SUNDRY NOTICES AND REPORTS ON WELLS
Do not use this form for proposals to drill or to re-enter an
abandoned well. Use form 3160-3 (APD) for such proposals.

Southern California 29 Federal No. 15

BOP Changes - Southern California 29 Federal No. 15

PECOS DISTRICT CONDITIONS OF APPROVAL

Exhibit D – Rig Diagram
Southern California 29 Federal No. 15
 Cimarex Energy Co. of Colorado
 29-19S-32E
 SHL 375 FSL & 330 FWL
 BHL 330 FSL & 330 FEL
 Lea County, NM

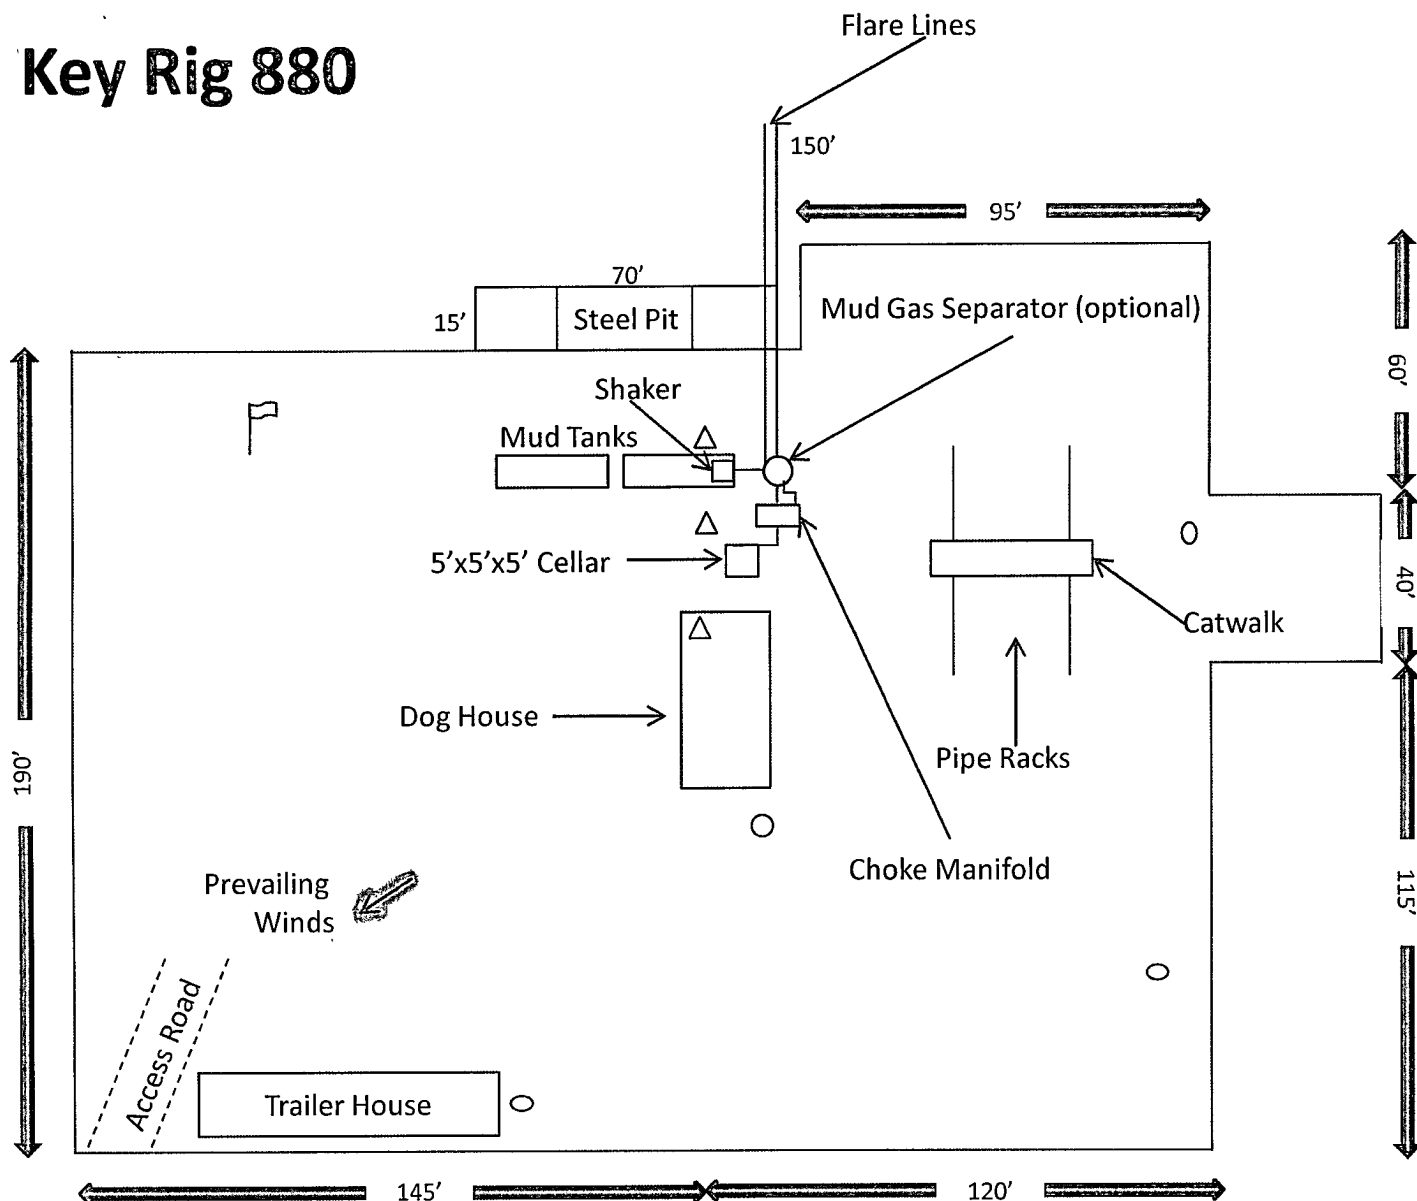
Change rig from Key 881 to sister Rig Key 880 with same rig footprint.

Exhibit E - 3000# BOP
Southern California 29 Federal No. 15
Cimarex Energy Co. of Colorado
29-19S-32E
SHL 375 FSL & 330 FWL
BHL 330 FSL & 330 FEL
Lea County, NM

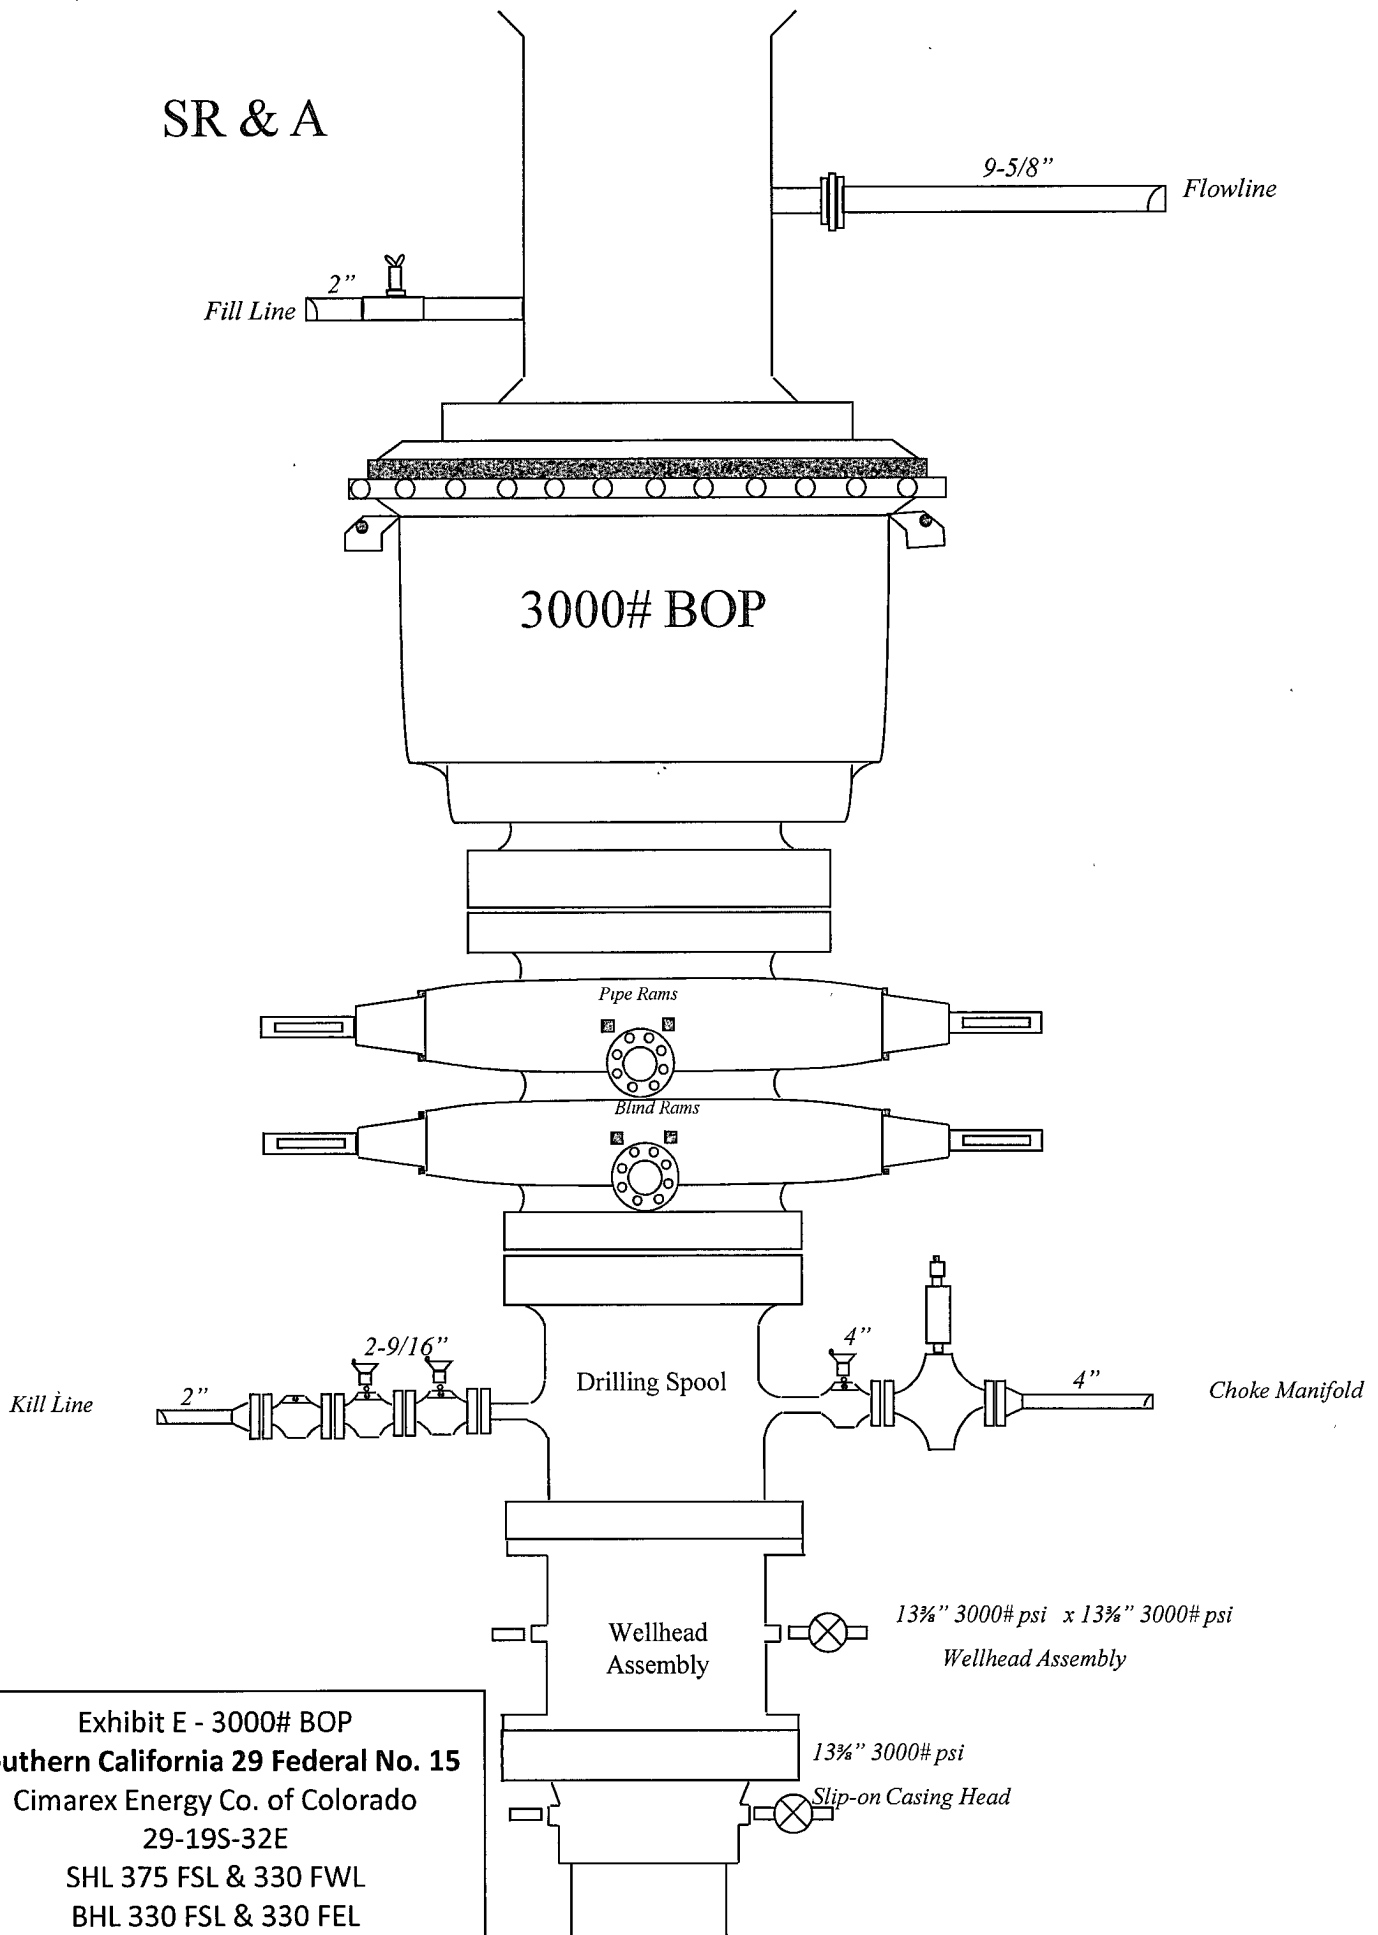
Change 5000# BOP system to dual 13 3/8" 3000# system while drilling out of the 13 3/8" casing shoe and a 11" 5000# system while drilling out of the 9 5/8" casing shoe. Choke Manifold remains same as permitted. See attached BOP diagrams and testing information.

Exhibit "E". A 13 $\frac{3}{8}$ " 3000 PSI working pressure B.O.P. consisting of one set of blind rams and one set of pipe rams and a 3000# annular type preventer. A choke manifold and 120 gallon accumulator with floor and remote operating stations and auxiliary power system. Rotating head below 920.' A kelly cock will be installed and maintained in operable condition and a drill string safety valve in the open position will be available on the rig floor.

2. Minimum working pressure of the blowout preventer (BOP) and related equipment (BOPE) required for drilling below the surface casing shoe shall be **3000 (3M) psi**.

Exhibit E-1 - 5000# BOP
Southern California 29 Federal No. 15
Cimarex Energy Co. of Colorado
29-19S-32E
SHL 375 FSL & 330 FWL
BHL 330 FSL & 330 FEL
Lea County, NM

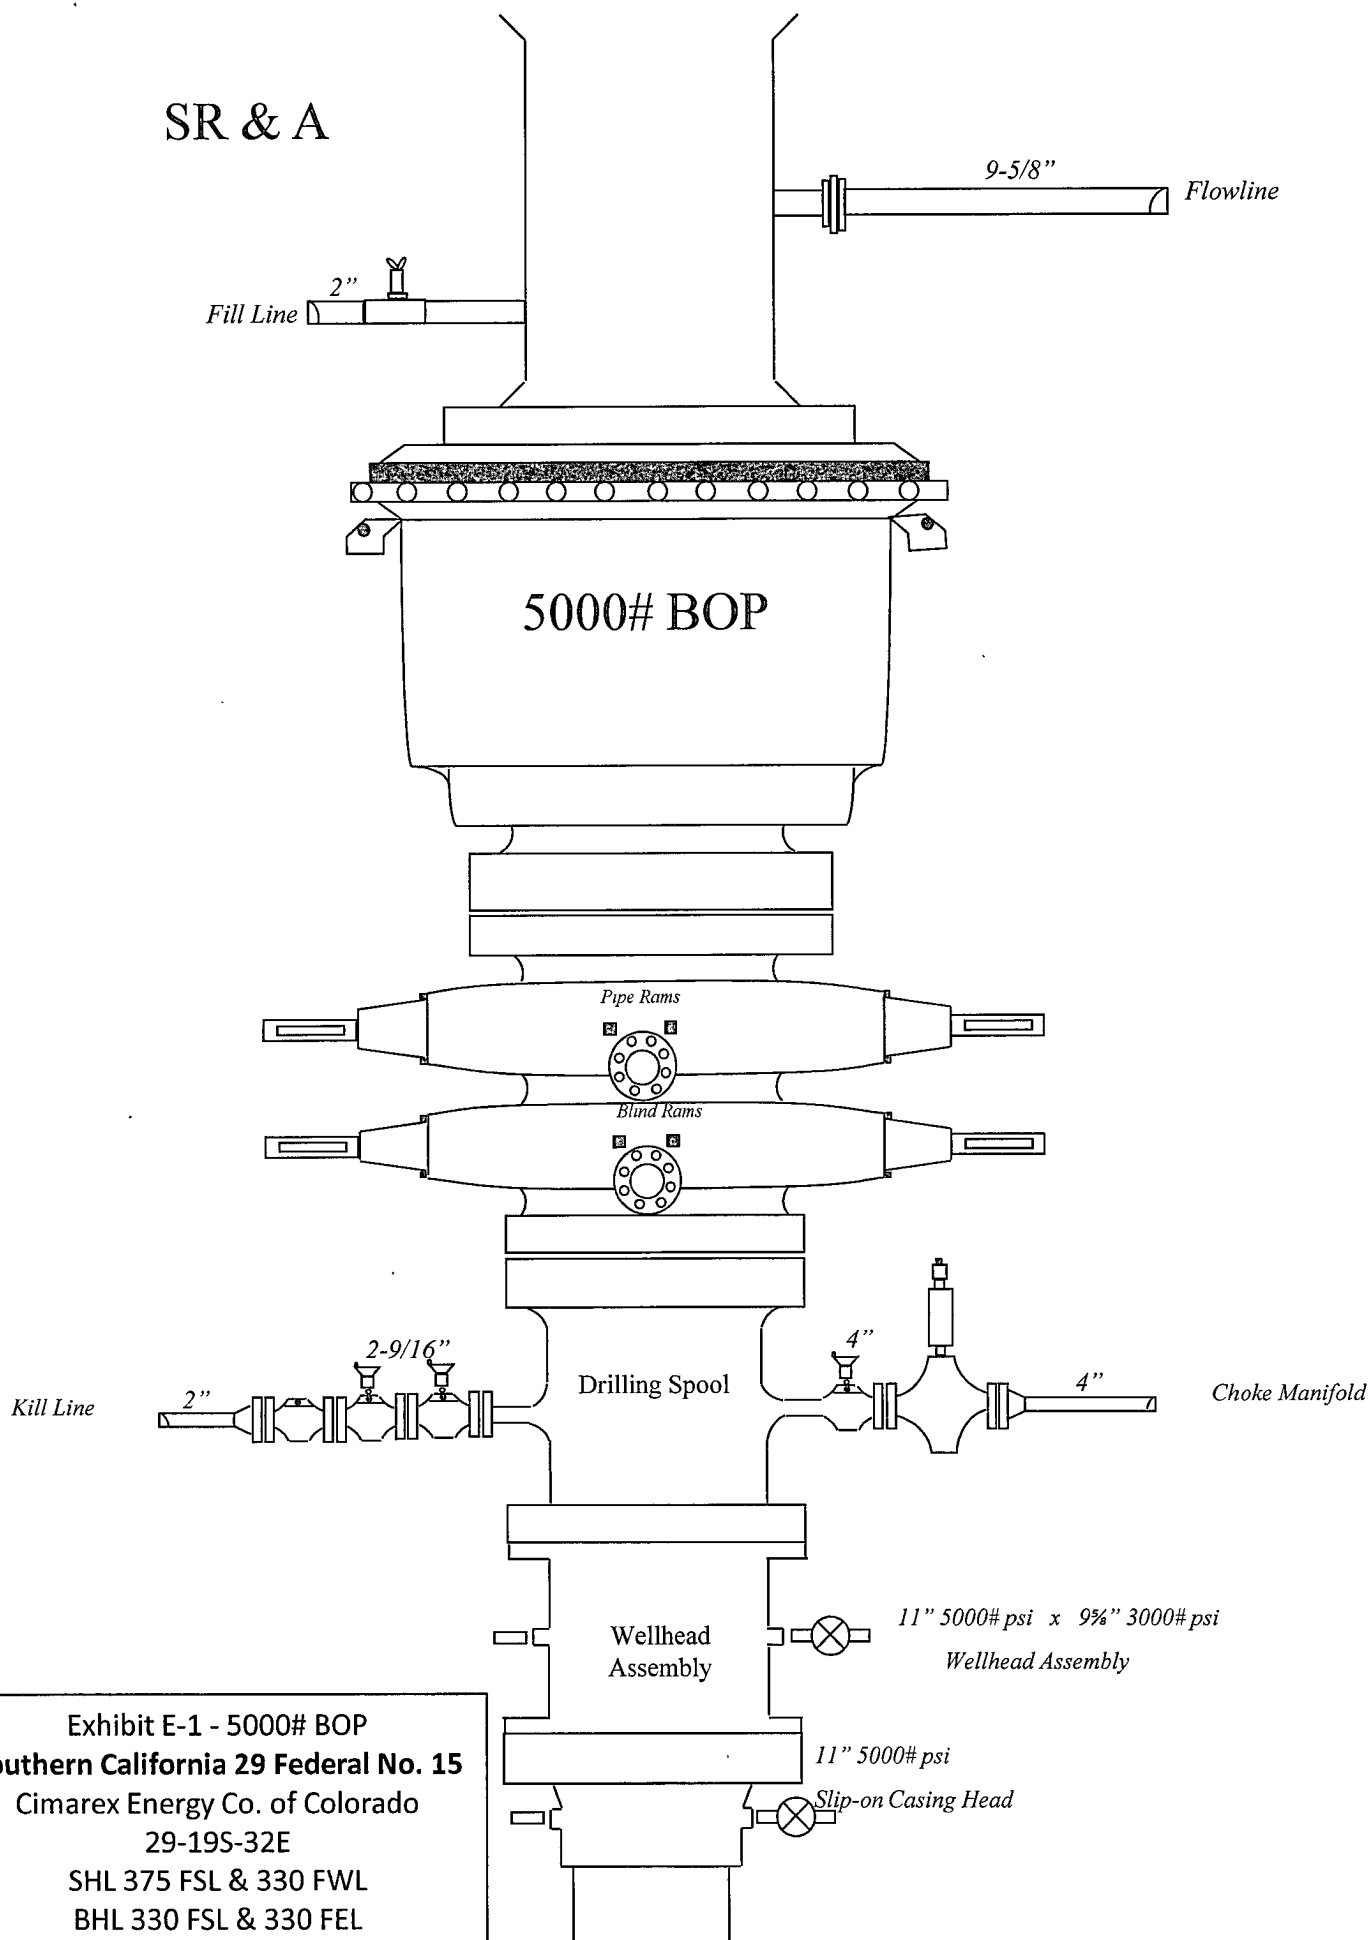
Exhibit "E-1". An 11" 5000 PSI working pressure B.O.P. consisting of one set of blind rams and one set of pipe rams and a 5000# annular type preventer. A choke manifold and 120 gallon accumulator with floor and remote operating stations and auxiliary power system. Rotating head below 4100.' A kelly cock will be installed and maintained in operable condition and a drill string safety valve in the open position will be available on the rig floor.

3. Minimum working pressure of the blowout preventer (BOP) and related equipment (BOPE) required for drilling below the 9-5/8 inch intermediate casing shoe shall be **5000 (5M) psi. 5M system requires an HCR valve, remote kill line and annular to match. The remote kill line is to be installed prior to testing the system and tested to stack pressure.**
